SUNDRY NOTICES AND REPORTS ON WELLS

COTTON DRAW UNIT 121H API# 30-015-37409 SEC 26 T24S R31E EDDY COUNTY, NM DRILLING SUNDRY 9.3.10

Devon Energy Production Co., LP NM-012121: Cotton Draw Unit #121H

RE: Changes to the APD – Conditions of Approval

11" x 3,000 psi BOP Stack

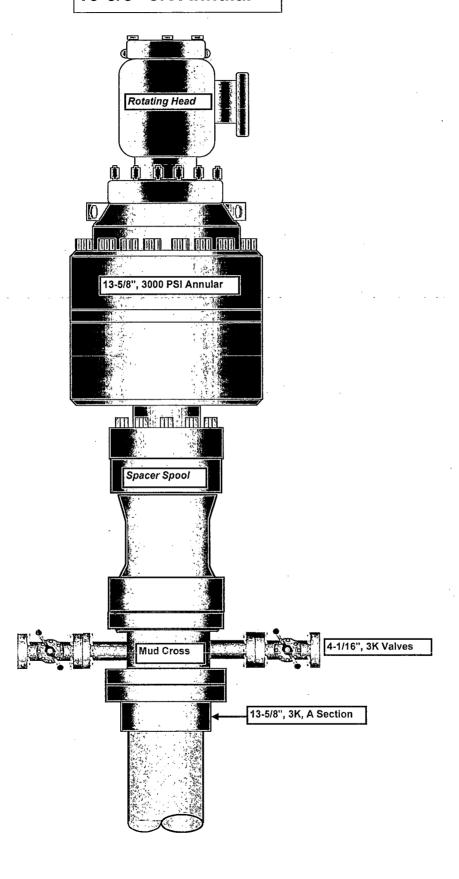
The BOP system used to drill the intermediate hole will consist of a 13-5/8" 3M Annular preventer. The BOP system will be tested as a **2M system** prior to drilling out the surface casing shoe.

The BOP system used to drill the production hole will consist of a 11" 5M Double Ram and Annular preventer. The BOP system will be tested as a 3M system prior to drilling out the intermediate casing shoe.

- 2. Minimum working pressure of the blowout preventer (BOP) and related equipment (BOPE) required for drilling below the surface casing shoe shall be **2000 (2M)** psi.

- 3. Minimum working pressure of the blowout preventer (BOP) and related equipment (BOPE) required for drilling below the 9-5/8 inch intermediate casing shoe shall be 3000 (3M) psi. 5M system tested as a 3M.

3M CHOKE MANIFOLD EQUIPMENT - CONFIGURATION OF CHOKES MAY VARY [54 FR 39528, Sept. 27, 1989]

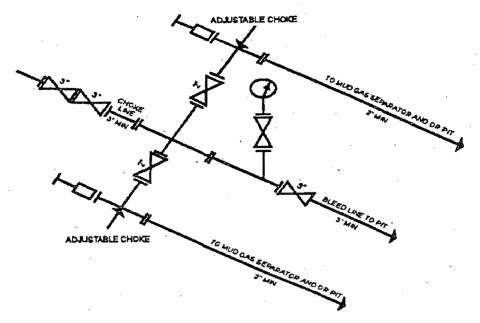
See attached BOP and choke manifold schematics.
